TransGrid Revenue Proposal 2023-28

# **REVIEW OF RIT-T PROJECT: MAINTAIN RELIABLE SUPPLY TO NORTHWEST SLOPES AREA NSW (PUBLIC VERSION)**

Report prepared for:  
**AUSTRALIAN ENERGY  
REGULATOR**  
August 2022

Figure 3.3: Peak demand forecast with voltage and thermal limits

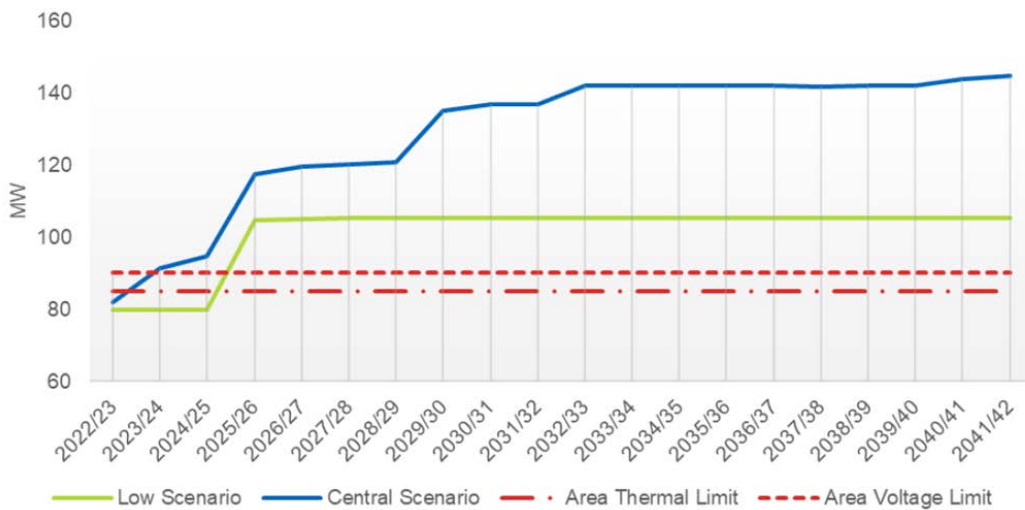
- 59. Since the PSCR was published in April 2021, demand forecasts for the area have reduced due to an update from Essential Energy in terms of load in its network as well as a specific spot load forecast no longer being expected to proceed. As a result, Transgrid removed consideration of the ‘high’ demand forecast in its PADR assessment and made minor revisions to its central and low demand forecasts.<sup>11</sup>
- 60. We understand that the demand forecasts published in the PADR are based on those provided in Transgrid’s 2021 Transmission Annual Planning Report and which was based on Essential Energy’s forecast. This is shown in Figure 3.3 below with the ‘low’ and ‘central’ scenario forecasts assumed in the analysis.

- 61. Since the PADR was published in February 2022, further changes have been made as detailed in Table 3.1.

Figure 3.6: Summary of the estimated net benefits, weighted across the three scenarios (weighted)

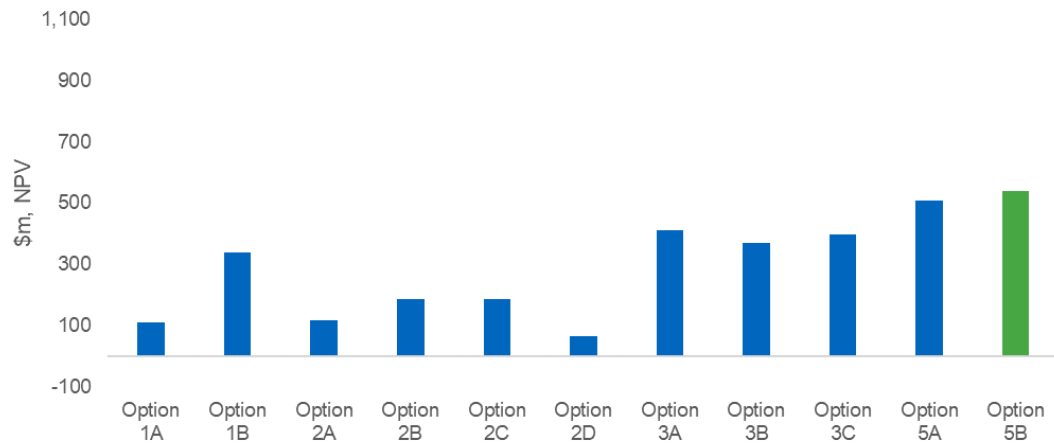
128. A summary of the NPV analysis for the central scenario is provided in Figure 3.6.
